Recall Bulletin

SUBJECT: Steering Wheel Fastener Inspection

MODELS: 2013 Buick Encore

This bulletin is being revised to include an illustration for Step 7 in the service procedure. Please discard all copies of bulletin 13098A.

3352589

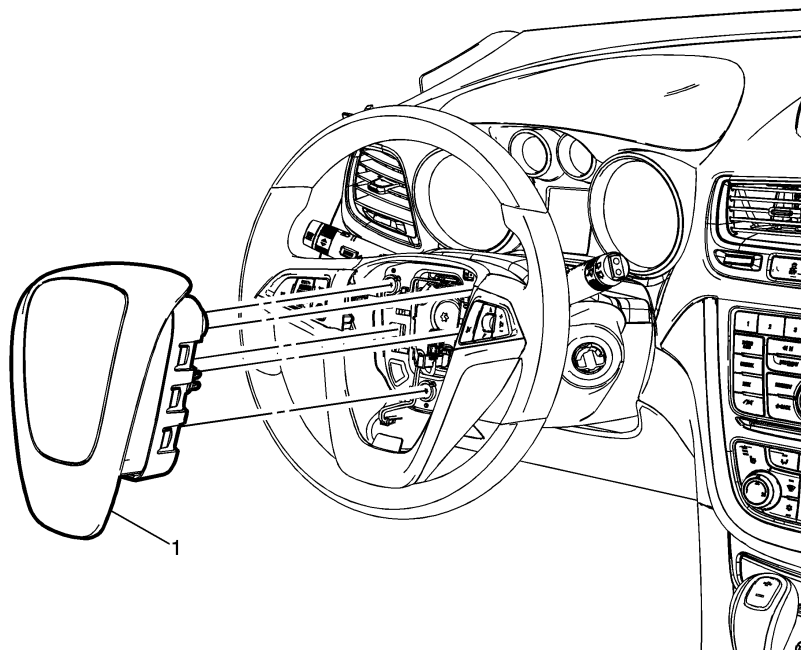
10. Inspect the hub area of the steering wheel for the attachment bolt (1).
- If the attachment bolt (1) is NOT present, install a new attachment bolt, P/N 11610164. Tighten the bolt to **30 Nm (23 lb-ft)**. Proceed to Step 11 after installing the new attachment bolt.
 - If the attachment bolt is present, apply a torque of 25 N·m (18 lb-ft) and verify that the bolt does not rotate. If the bolt rotates, remove it and replace it with P/N 11610164. Tighten the bolt to **30 Nm (23 lb-ft)** using a torque wrench.
